NO. H97D-001

SUBJECT: BP 250 BLOWER RETURN LINE SLEEVE

AFFECTS: BP 250 BACKPACK BLOWERS
UT08017F, G
SERIAL NUMBER HP2000001 THROUGH HR2109999

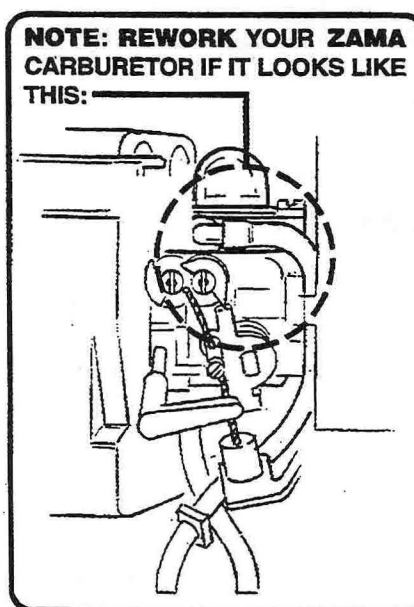
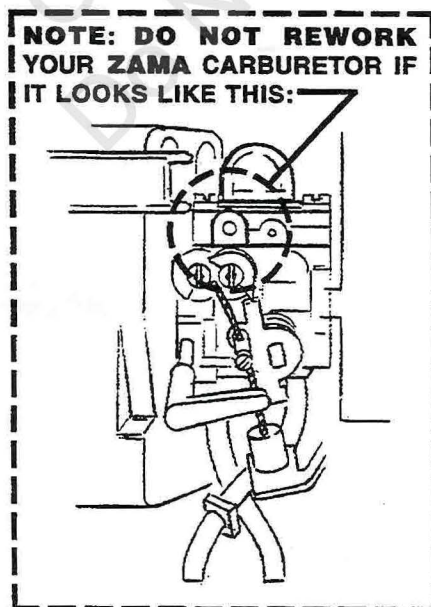
The above indicated blowers may require rerouting and adding a sleeve to the return line from the carburetor to the fuel tank. The sleeve will prevent the return line from cracking or melting due to heat from the cylinder and crankcase. The sleeve also prevents chafing which can occur from contact with the routing bracket. **The sleeve should be installed on all units with Walbro carburetors. Further, the sleeve should be installed on Zama carburetors using a 4mm return line. Do not rework Zama carburetors with 3mm return lines.** See illustration below to help identify the affected Zama carburetor

Carburetor: Zama 3mm: no fitting on
choke lever side, no rework required

Carburetor: Zama 4mm: fitting on
choke lever side, add sleeve kit
to return line

NOTE: REWORK YOUR ZAMA CARBURETOR IF IT LOOKS LIKE THIS:

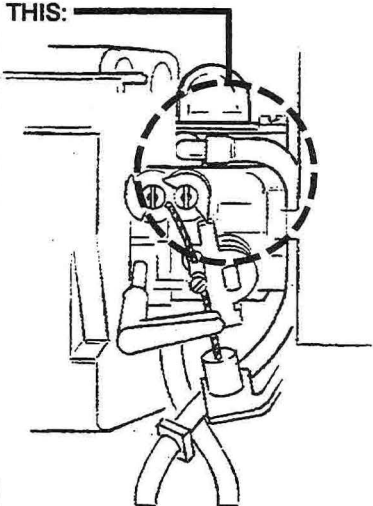
INSTRUCTIONS FOR BOTH ZAMA & WALBRO CARBURETOR REPAIR:

1. Remove the return line from the carburetor and fuel tank.
2. Using a fuel line puller, install **new** return line in fuel tank.
3. Trim **sleeve** as per illustration.
4. Slide sleeve over return line.
5. Trim return line to fit.
6. *Make sure that the sleeved line does not contact cylinder or crankcase.*
7. Connect return line to carburetor.

ZAMA CARBURETORS

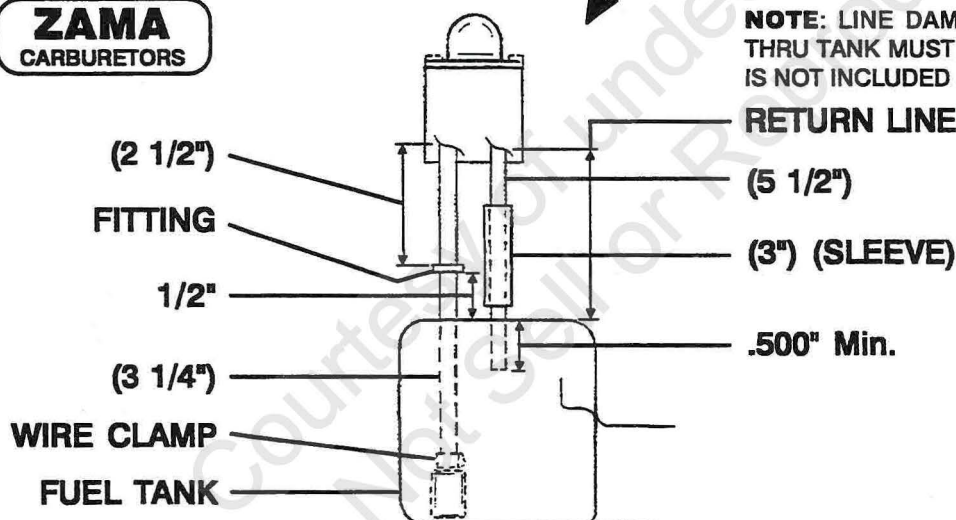
NOTE: LINE DAMAGED WHEN PULLED THRU TANK MUST BE CLIPPED OFF. THIS IS NOT INCLUDED IN SPECIFIED LENGTH.

RETURN LINE 4" OUT OF TANK

WALBRO CARBURETORS

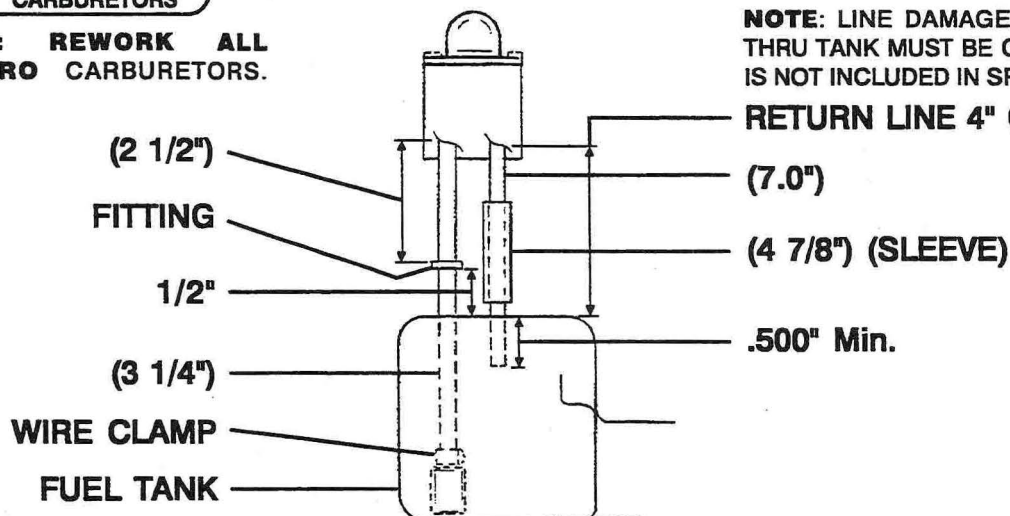
NOTE: REWORK ALL WALBRO CARBURETORS.

NOTE: LINE DAMAGED WHEN PULLED THRU TANK MUST BE CLIPPED OFF. THIS IS NOT INCLUDED IN SPECIFIED LENGTH.

RETURN LINE 4" OUT OF TANK
